CONSTRUCTION DOCUMENTS

FALCON MARKETPLACE

SF-19-001

75% SUBMITTAL 12-20-18

FALCON
MARKETPLACE
PLAN & PROFILE

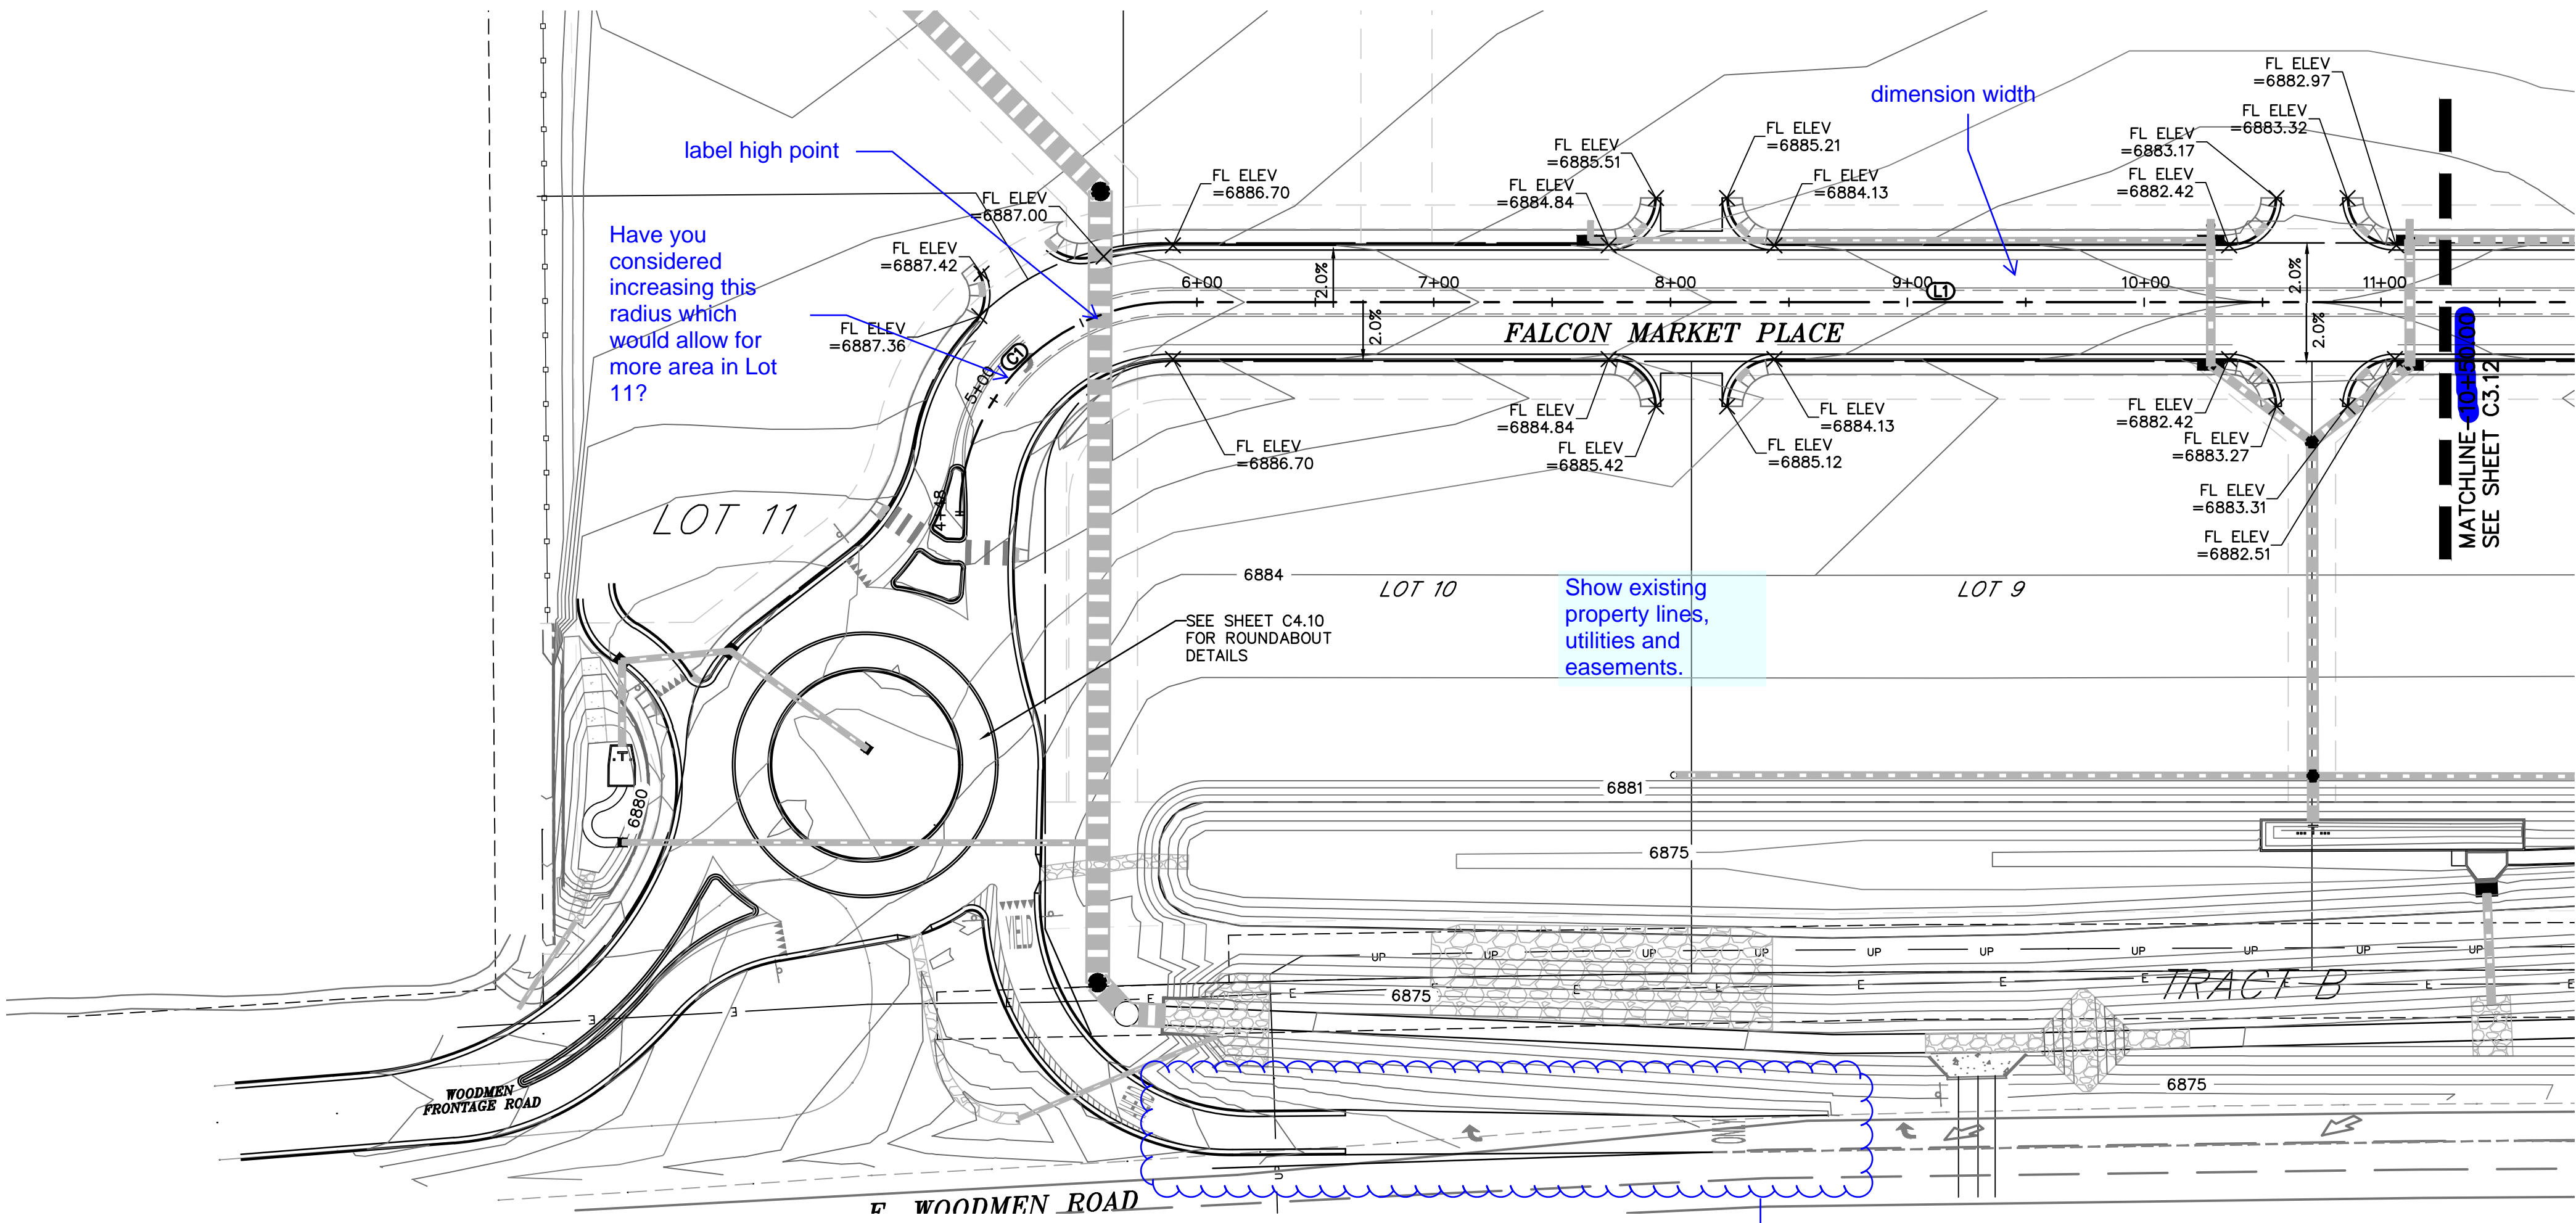
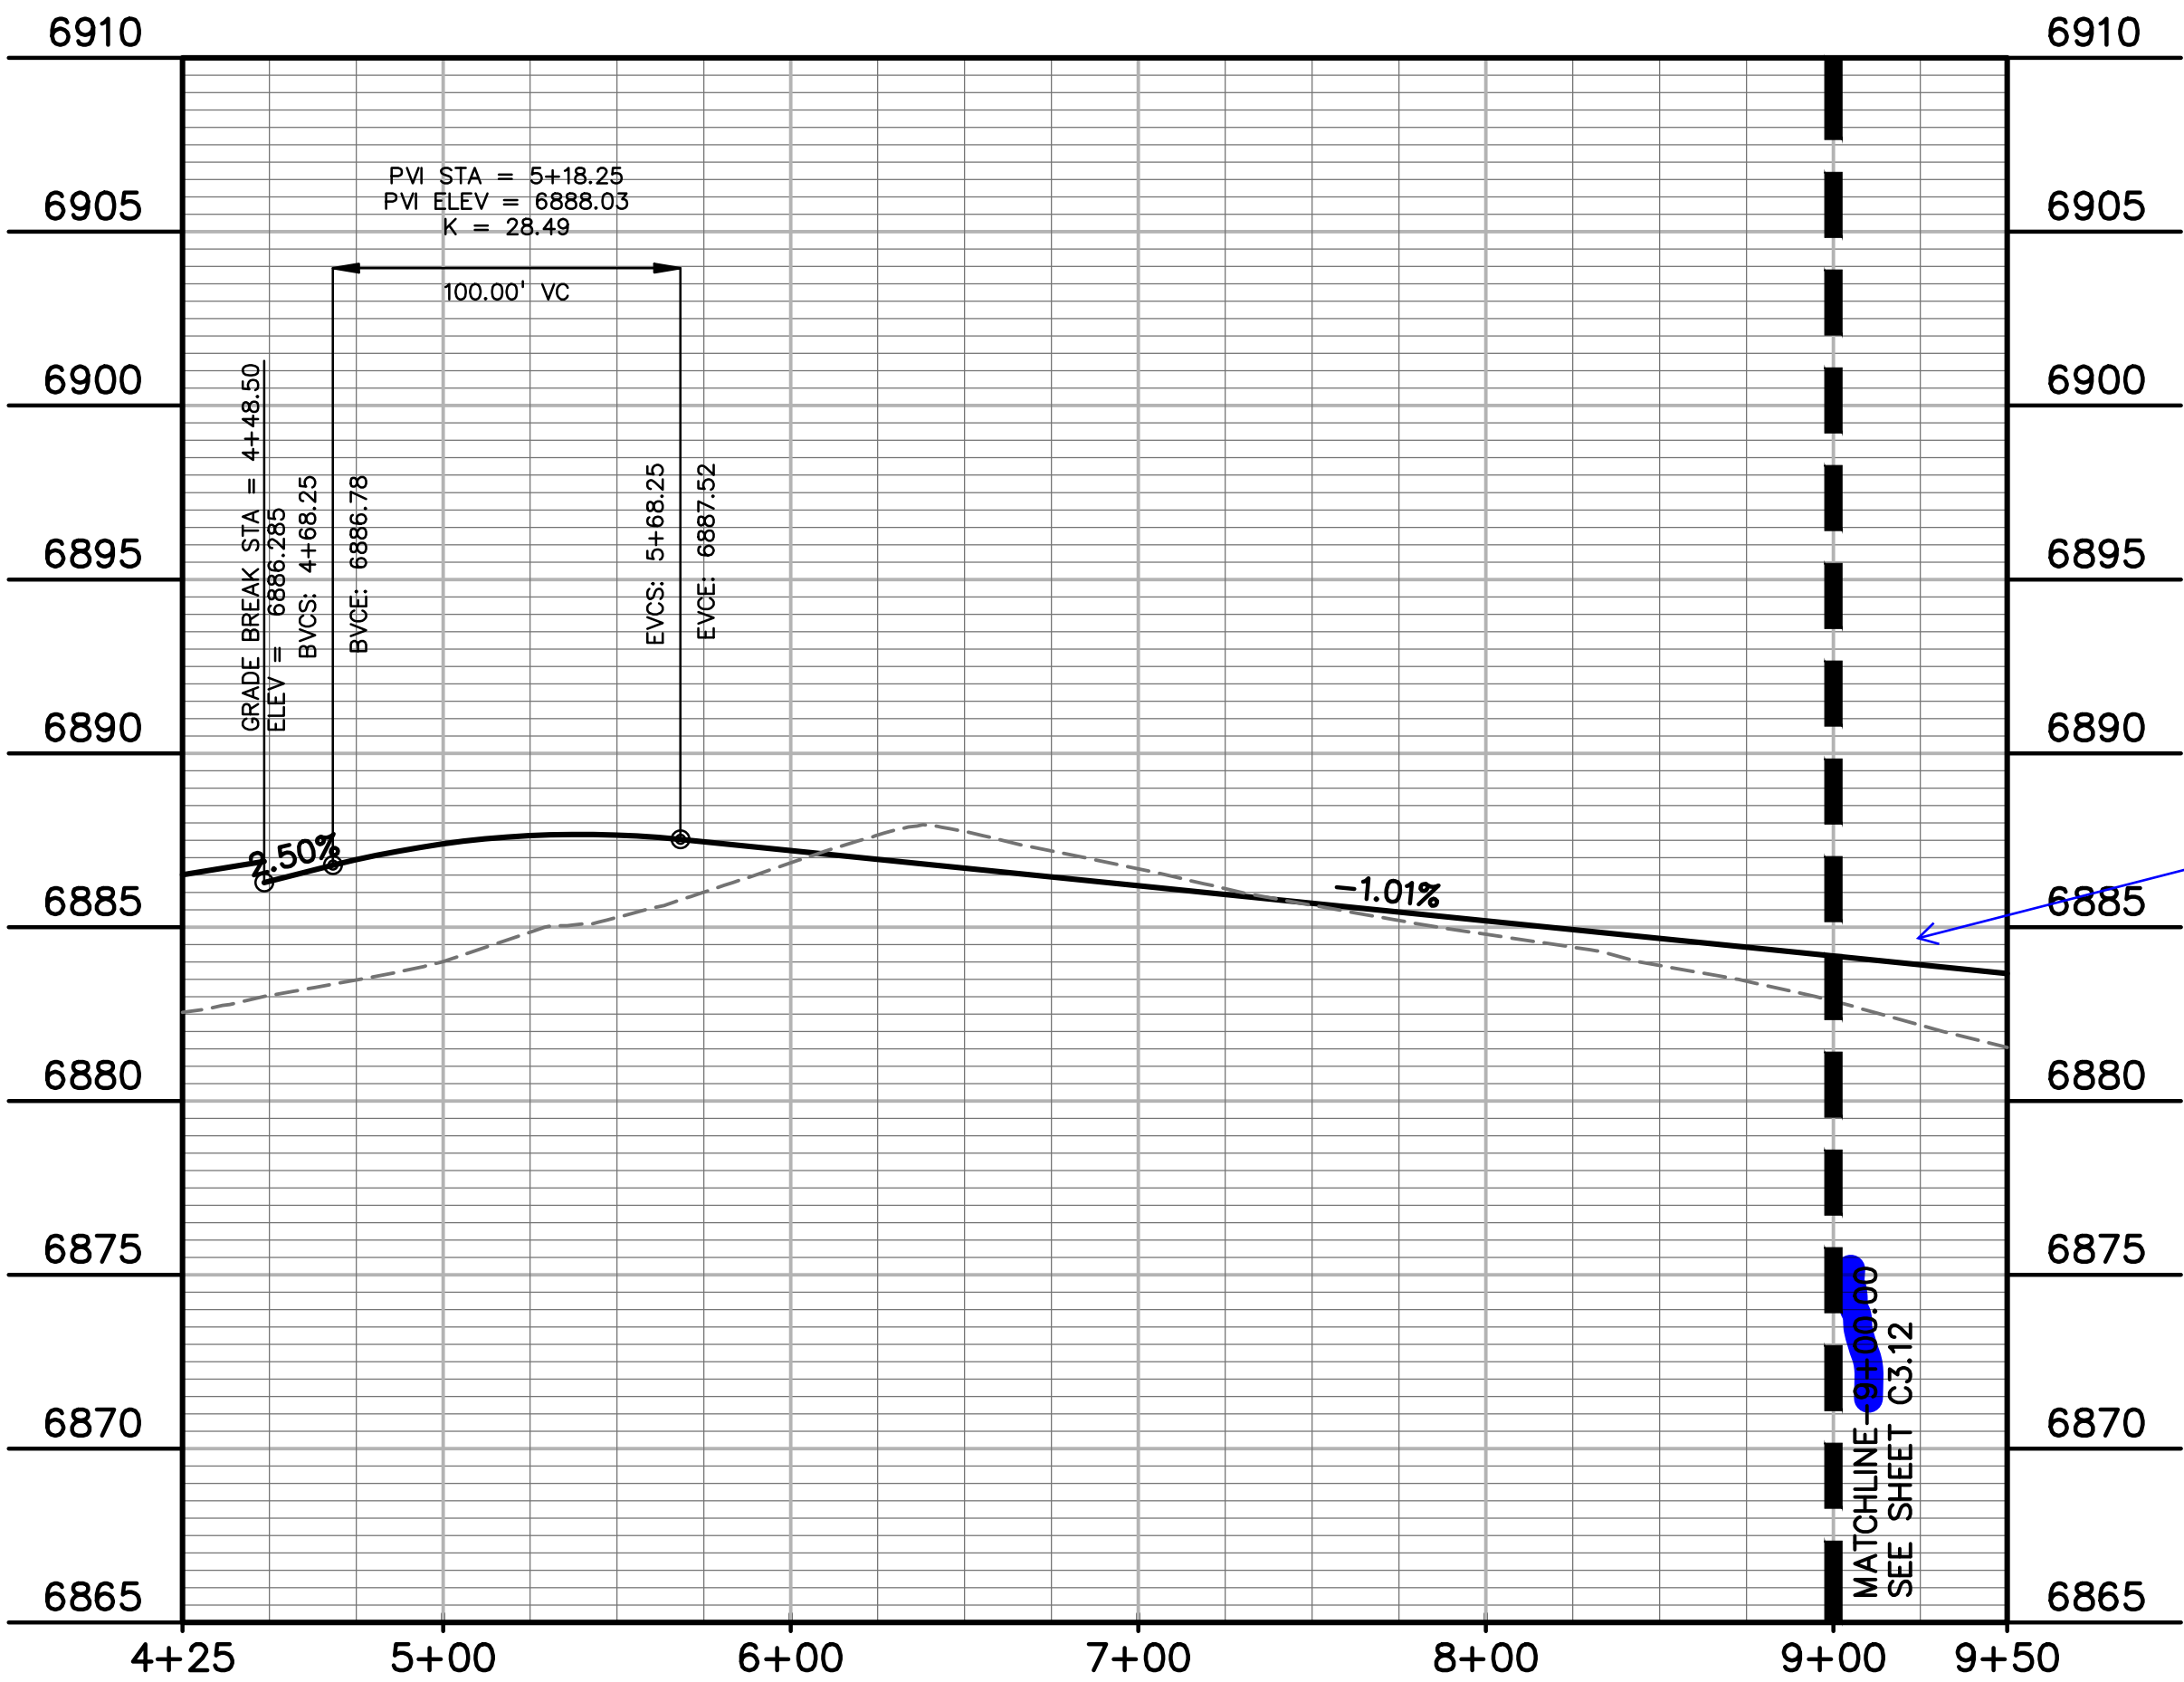
Provide standard pedestrian ramps (not radial). Ensure that all ADA paths are ADA compliant.

Provide details.

Show profile to ~12+00
